ADDENDUM NUMBER 2

LINDBERGH PARK PAVILION AND SLASH PAD CONSTRUCTION

Project Number: P070-12417

Date of Addendum: April 17, 2013

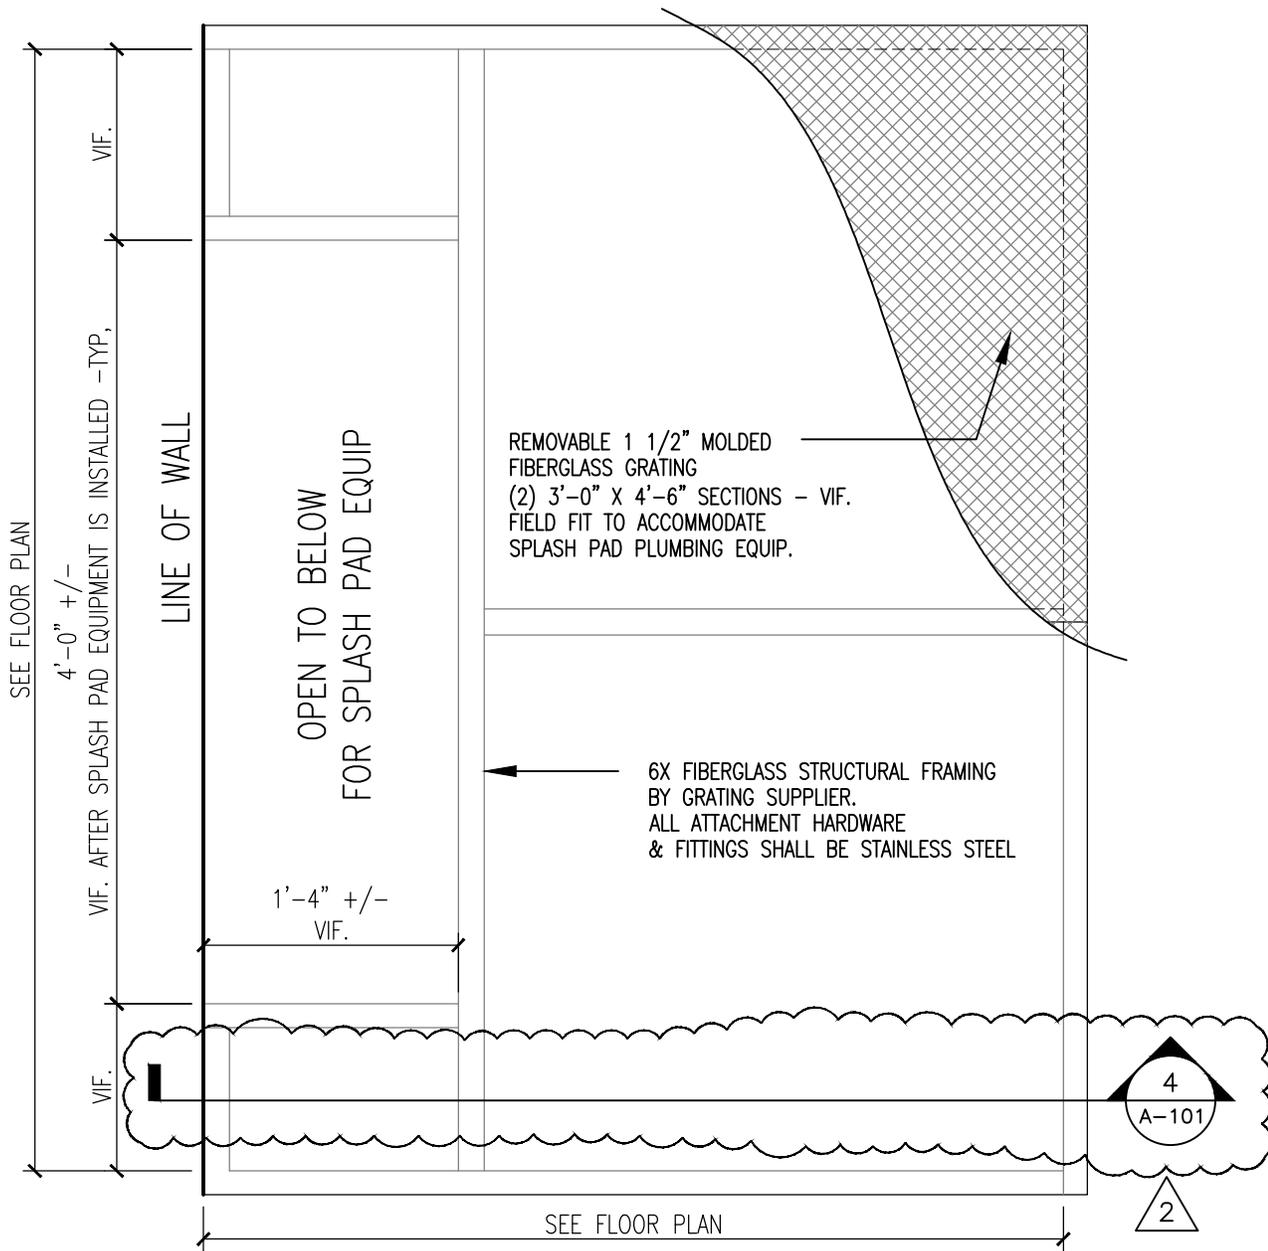
- c. **CLARIFICATION**: EGRESS WIDTH CALCULATIONS TABLE, SHELTER OCCUPANT LOAD is “34”. See attached drawing A-000.
- d. MINIMUM NUMBER OF REQUIRED PLUMBING FIXTURES TABLE, **DELETE** “VETERANS PARK PAVILION” **REPLACE WITH** “ LINDBERGH PARK PAVILION”. See attached drawing A-000.

EGRESS WIDTH CALCULATIONS				
ROOM / SPACE	USE OR OCCUPANCY	OCCUPANT LOAD	EGRESS COMPONENT FACTOR	REQUIRED EGRESS COMPONENT WIDTH
WOMEN'S TOILET ROOM	ASSEMBLY (A-5)	12	0.2 INCHES / OCCUPANT	2.4-INCHES
MEN'S TOILET ROOM	ASSEMBLY (A-5)	12	0.2 INCHES / OCCUPANT	2.4-INCHES
UTILITY ROOM	MECHANICAL	1	0.2 INCHES / OCCUPANT	N/A
SHELTER	ASSEMBLY (A-5)	34	N/A - UNRESTRICTED EGRESS TO EXTERIOR

5 FIBERGLASS GRATING PLAN
 A-101 1" = 1'-0"

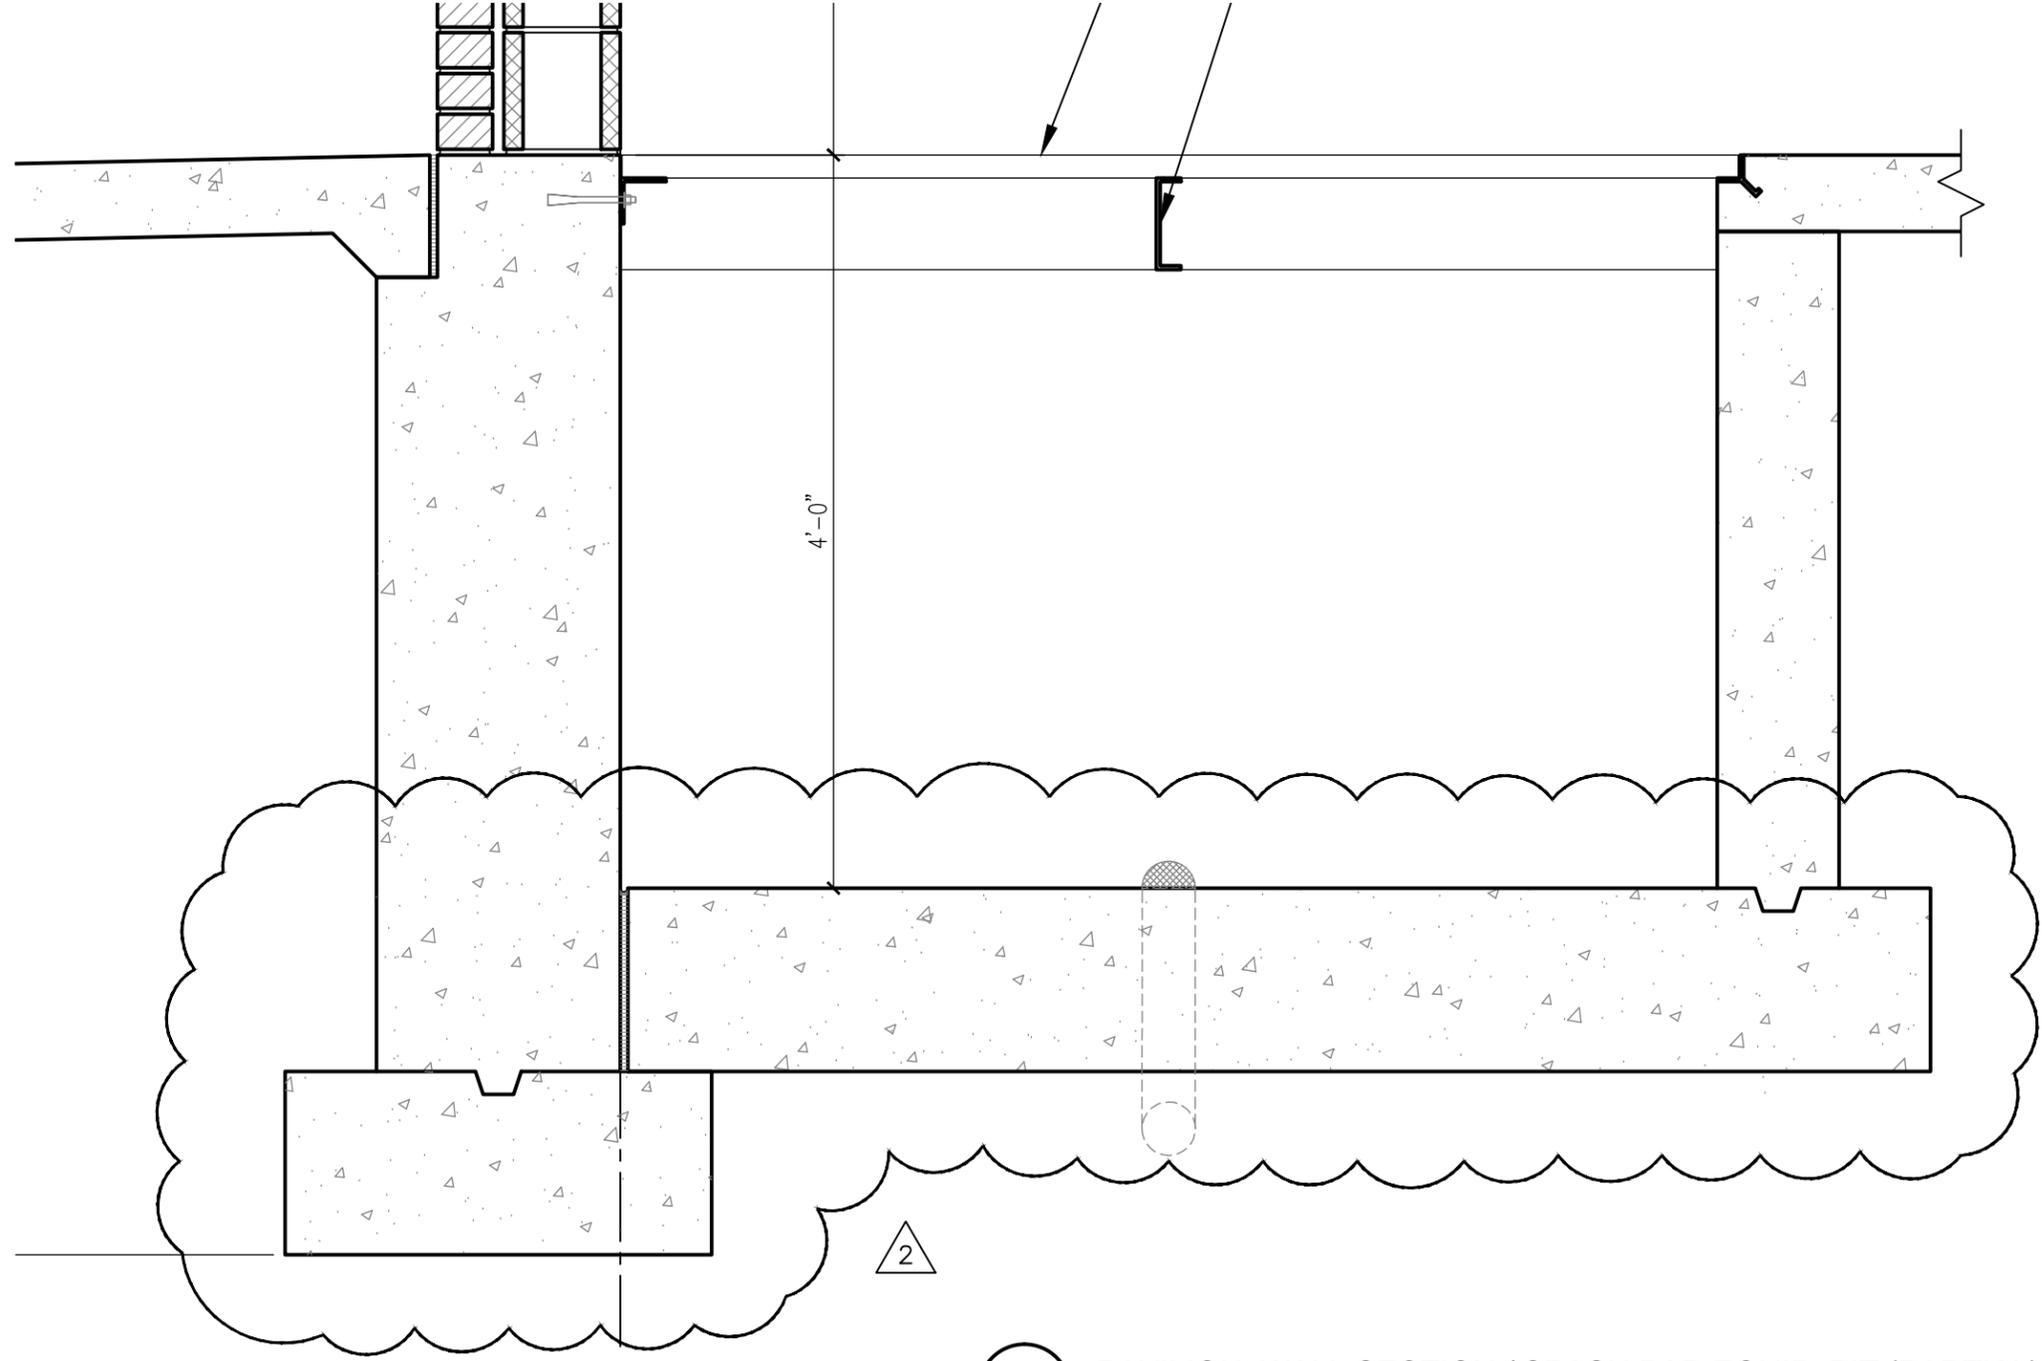
- a. Drawing 4/A-101, **REVISE** drawing scale to 1” = 1’-0”.
- b. Drawing 5/A-101, **REVISE** detail callout to section callout. See attached drawing A-101.
- c. Drawing 5/A-101, **REVISE** drawing scale to 1” = 1’-0”.
- d. **CLARIFICATION**: Plan Note “6” is typical for all type “C” partitions.

2 PARTIAL ABOVE FLOOR PLUMBING PLAN
 P2.0 1/4" = 1'-0"

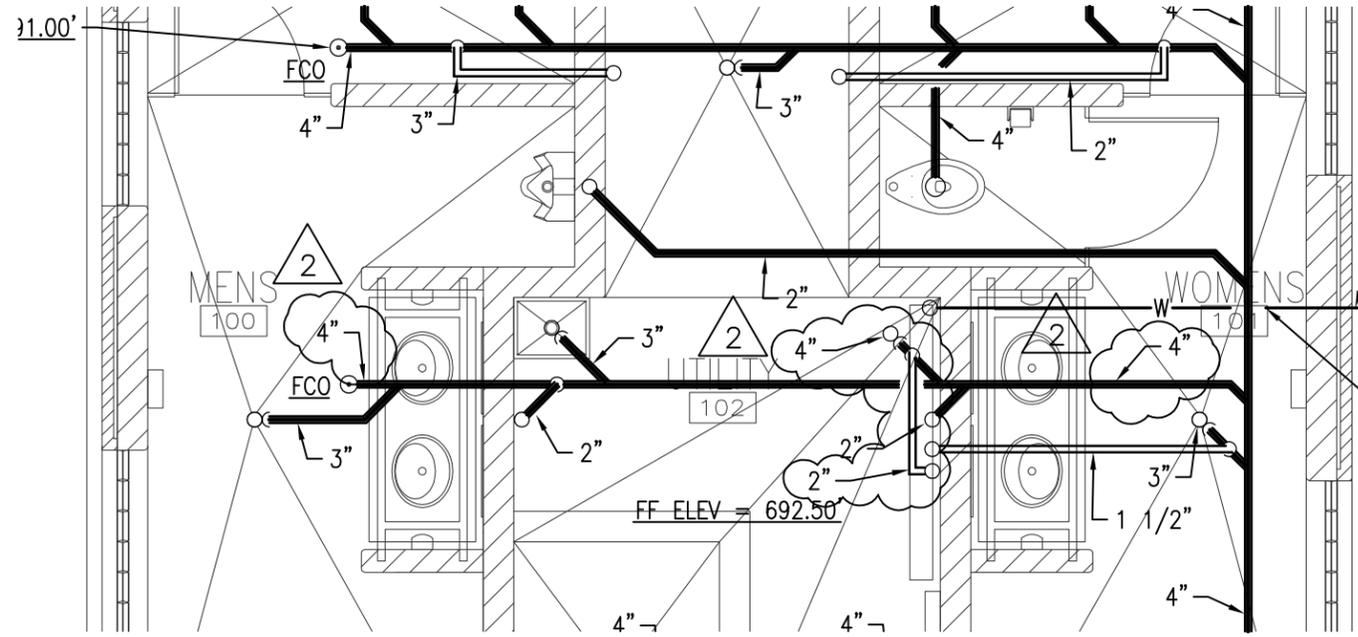
- a. **ADD** floor drain (FD-2) to in mechanical chase 102. See attached drawing P-1.
- b. **ADD** drain valves at low point to lavatories. No drawing attached.
- c. **ADD** drain valve at low point to wall hydrant. No drawing attached.
- d. **CHANGE** sanitary line to 4”. See attached drawing P-1.

ADDENDUM 02
REF. SHT: EL

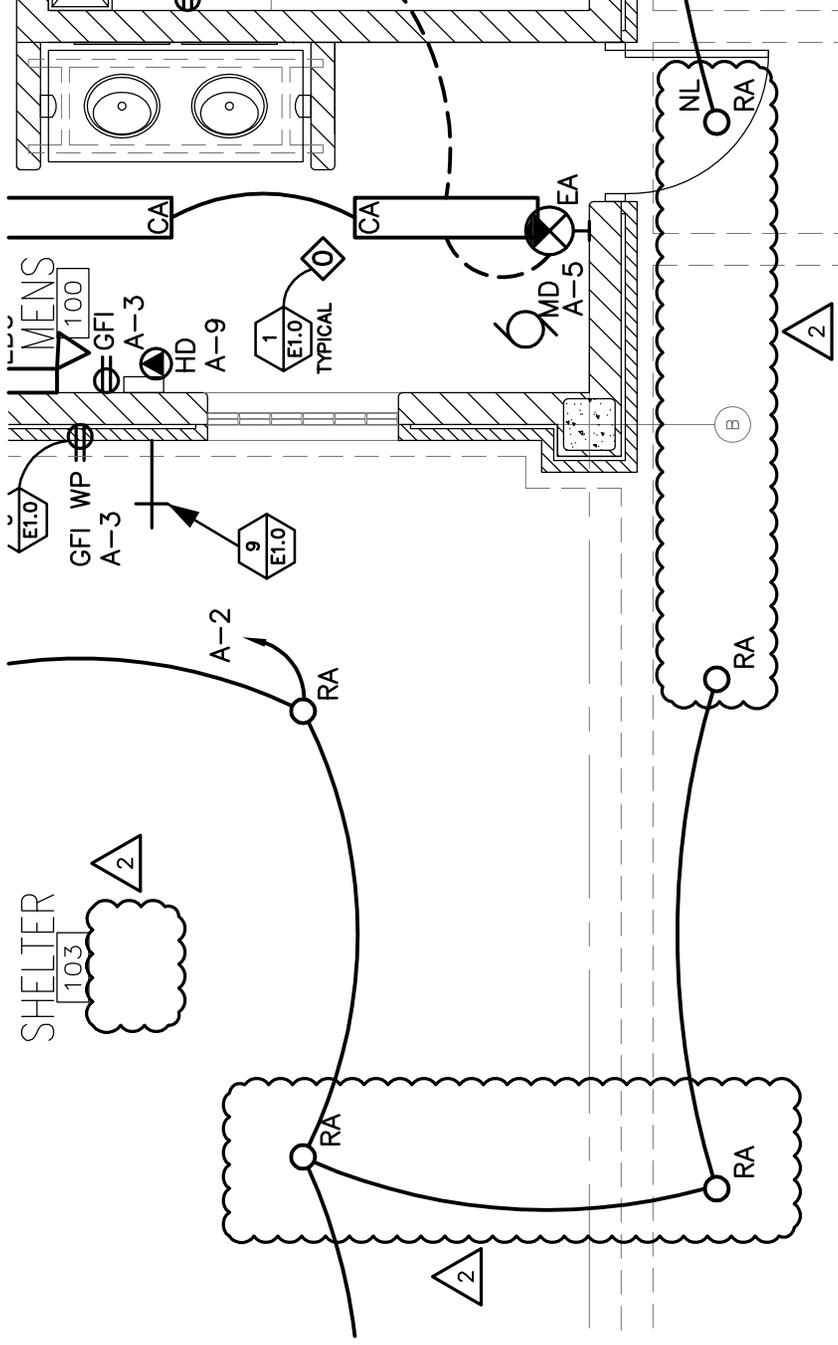
- a. **ADD** "Nightlight" symbol. See Sheet E01.

EXTERIOR LIGHTING CONTROL RISER

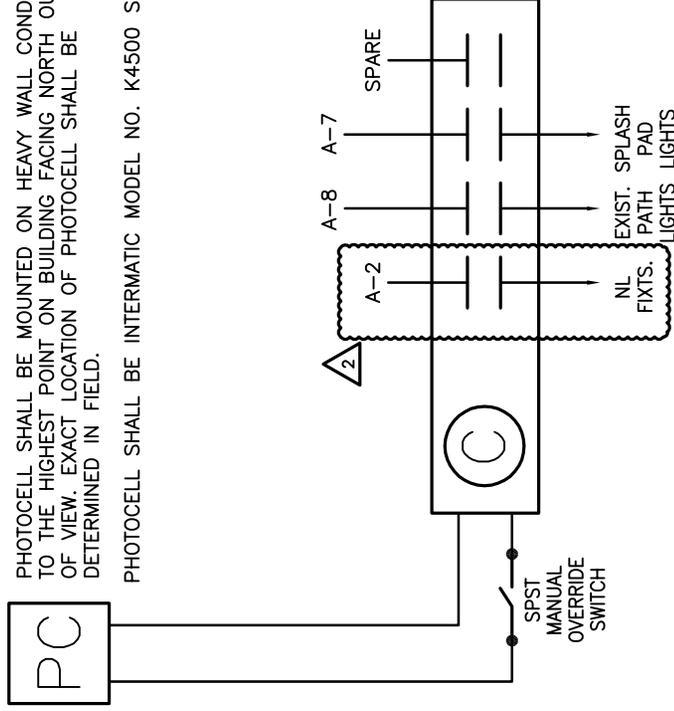
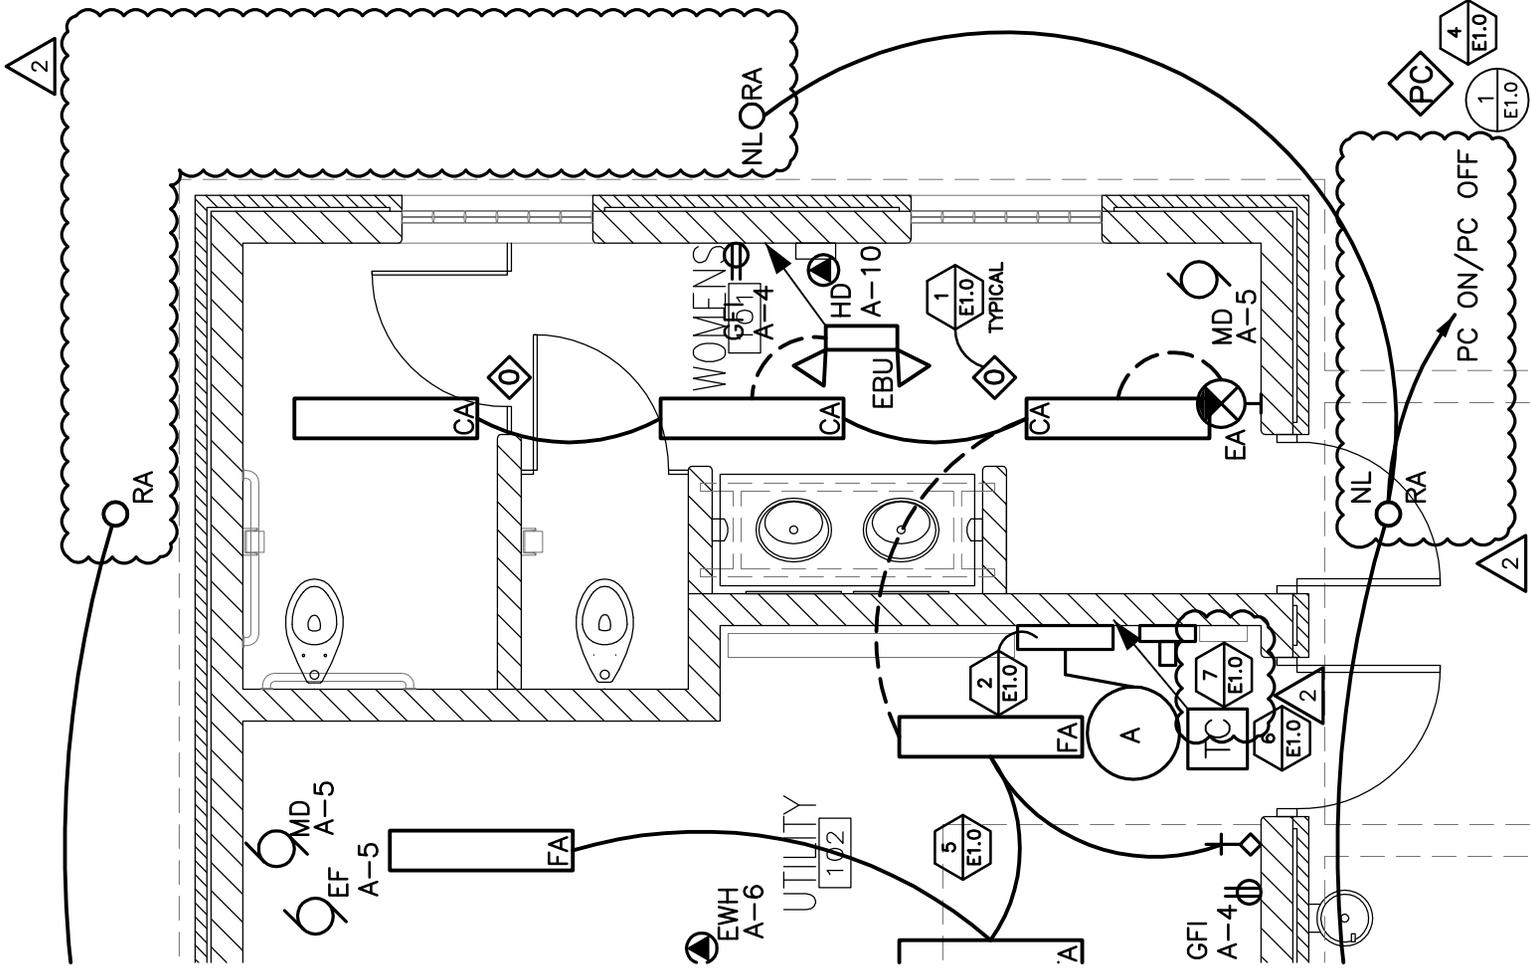
- a. Drawing E02 / Sheet E1.0: **CHANGE** Detail 1/E1.0. See attached drawing E02.
- b. **CHANGE** circuiting/control for Type "RA" light fixtures. See attached drawings E02 and E03.

PHOTOCELL SHALL BE MOUNTED ON HEAVY WALL CONDUIT TO THE HIGHEST POINT ON BUILDING FACING NORTH OUT OF VIEW. EXACT LOCATION OF PHOTOCELL SHALL BE DETERMINED IN FIELD.

PHOTOCELL SHALL BE INTERMATIC MODEL NO. K4500 SERIES
